Goulburn Base Hospital Redevelopment

*State Significant
Development Modification
Assessment
(SSD 8667 MOD 2)
January 2020*

Figure 6 | Proposed level 3 plan (Source: Modification 2 Application)

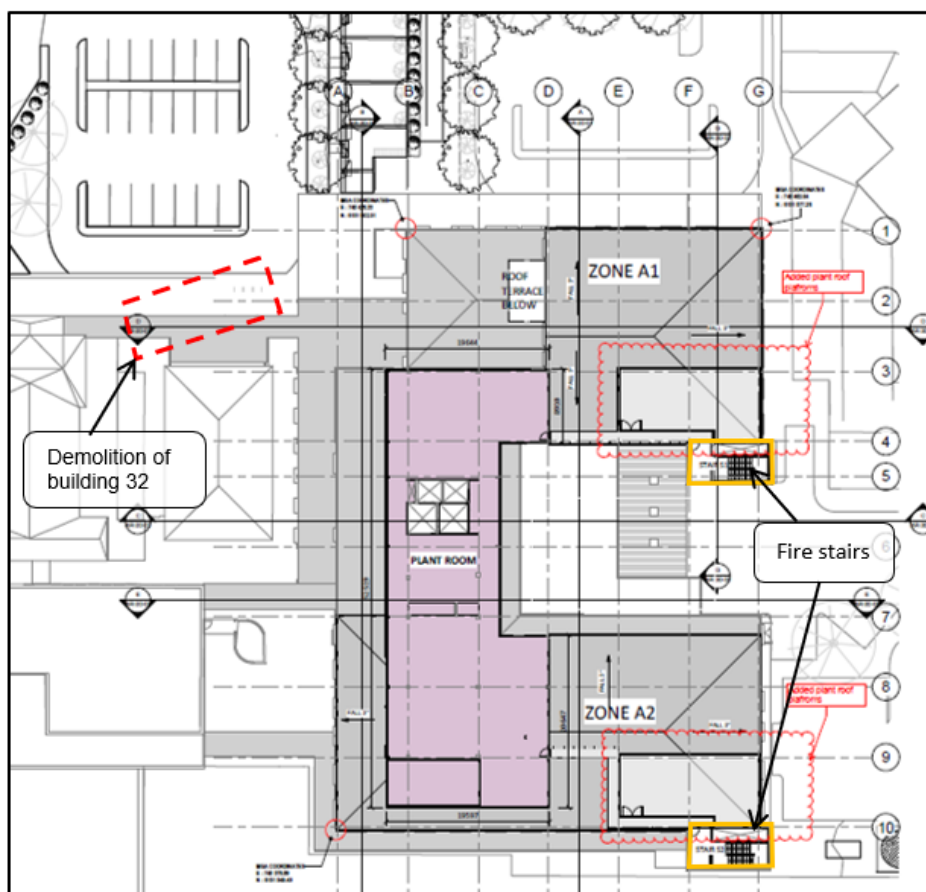
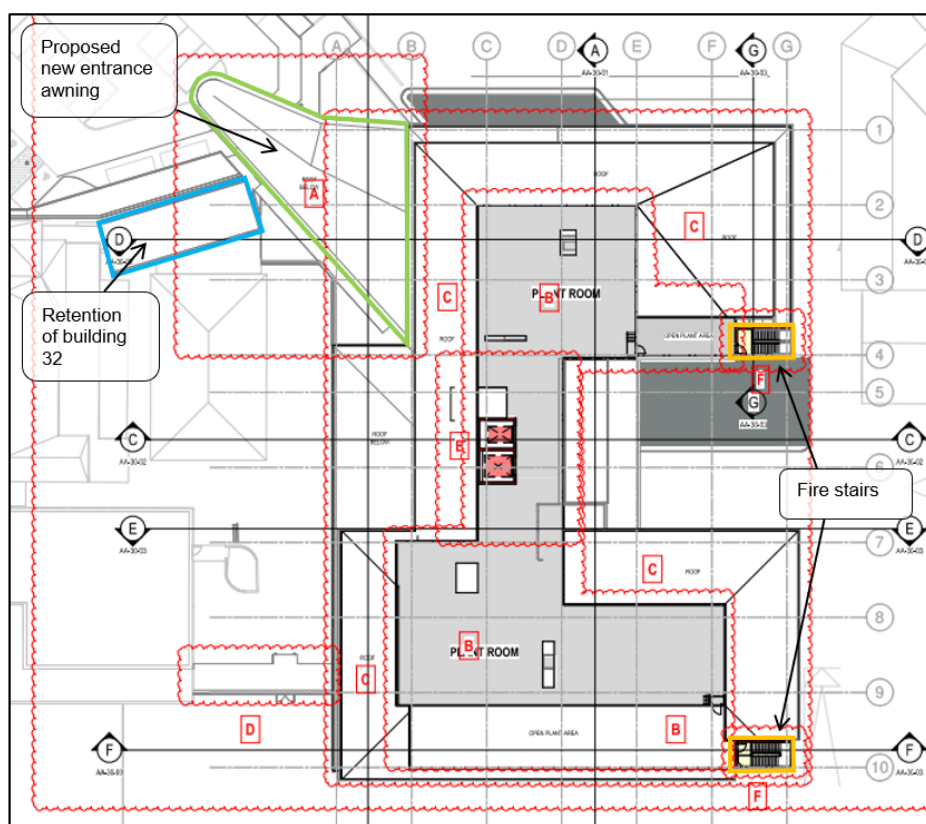
Comparison of the approved and proposed floor plan in **Figures 5** and **6** illustrate the retention of Building 32 and that the proposed modification has otherwise maintained a similar footprint. The plant room level is repositioned (see **Figure 5** and **6**), however it does not result in increased bulk and scale as perceived from Goldsmith Street (see **Figure 4**). The fire stairs are visible on the eastern elevation and the floor plans as depicted in **Figures 5** to **8**. Currently the fire stairs appear to be a separate structure abutting the building, however the modification proposes to incorporate and align the fire stairs into the overall building maintaining the 'C' shape floor plan. The fire stairs now form the edges of the proposed building rather than protruding out from the building form. To ensure that articulation is still provided along the façade, the treatment of the fire stairs differs to contrast it from the rest of the building (see **Figure 8**).

The Department has reviewed the proposed built form changes and is satisfied that the elements as depicted are acceptable and that the overall changes will result in the development being substantially the same bulk and scale as the approved development. The revised design also continues to be sympathetic to nearby heritage buildings.

Figure 8 | Proposed East elevation (Source: Modification 2 Application)

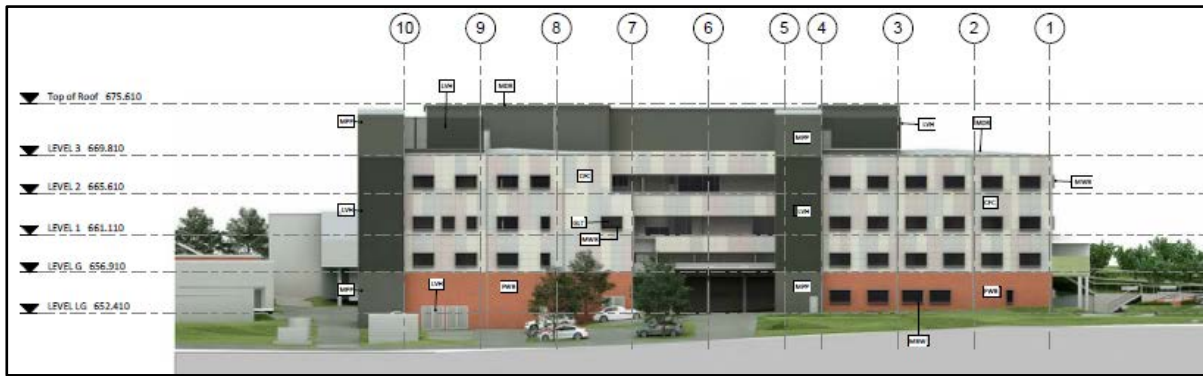
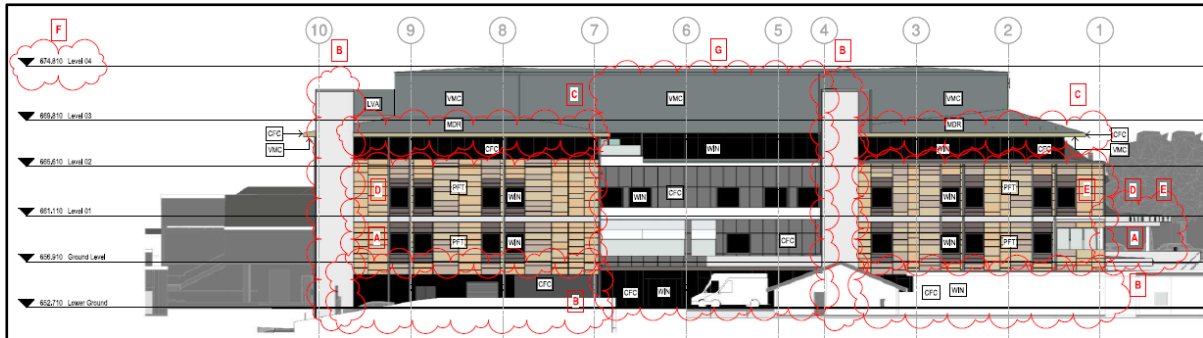
Figures 9 to **11** depict the internal/external alterations to the ASB, detailing bulk and height variations.

Figure 13 | Proposed landscaping (Source: Modification 2 Further information)

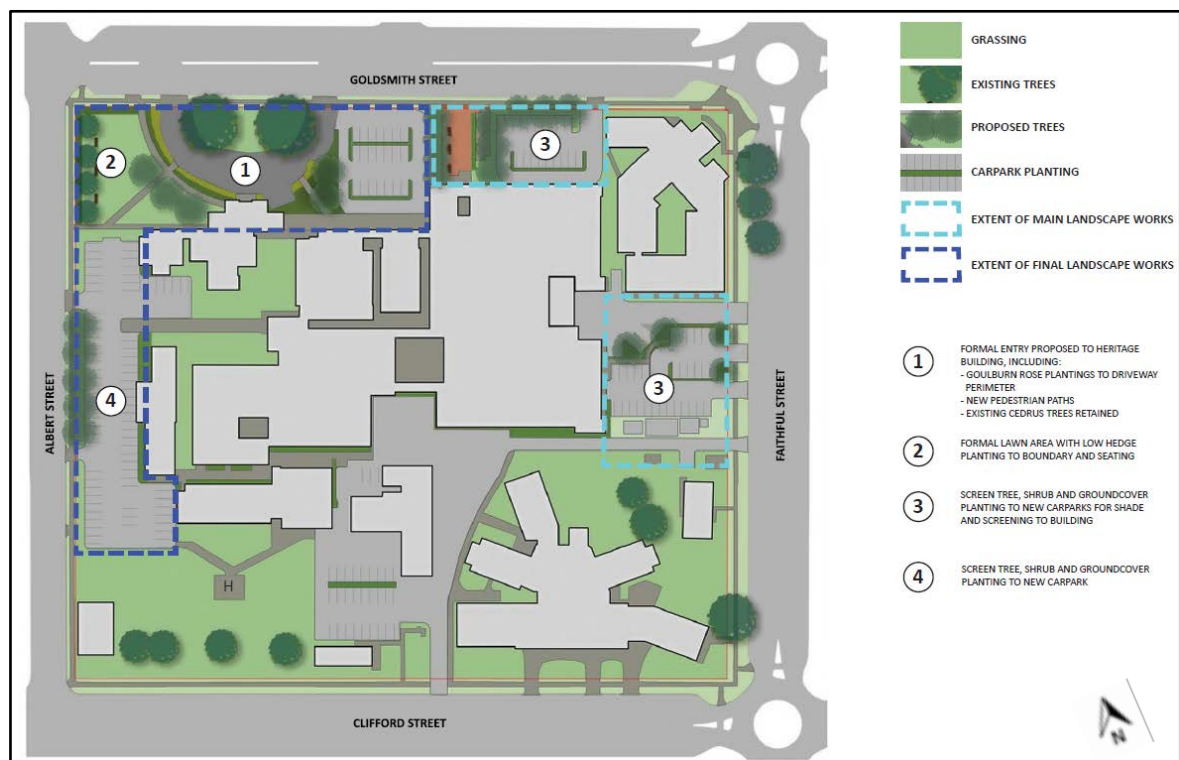
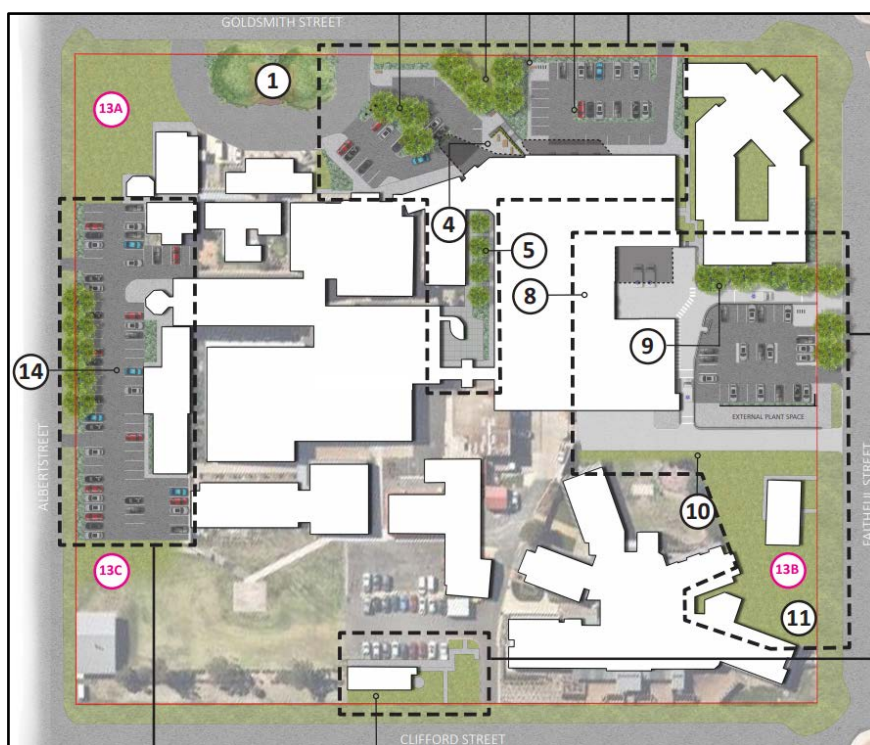
The landscape plans submitted as part of the proposed modification depicted landscaping for the north, east and south of the site. The Department requested that the Applicant provide updated landscape plans that considered landscaping across the whole site including the western car park. The approved landscape plan is depicted in **Figure 12** and the proposed landscape plan is depicted in **Figure 13**.

The proposal includes the addition of landscaping to the internal courtyard between the new ASB and the existing buildings on site. The landscaping incorporates hedging, screening and evergreen plant species to complement the surrounding area. The planting proposed would not restrict views for vehicles and pedestrians. The landscaping is expected to complement the heritage features and provide appropriate soft space.

The Department is satisfied that the proposed reconfigured landscaping is appropriate and will soften the overall appearance of the ASB.
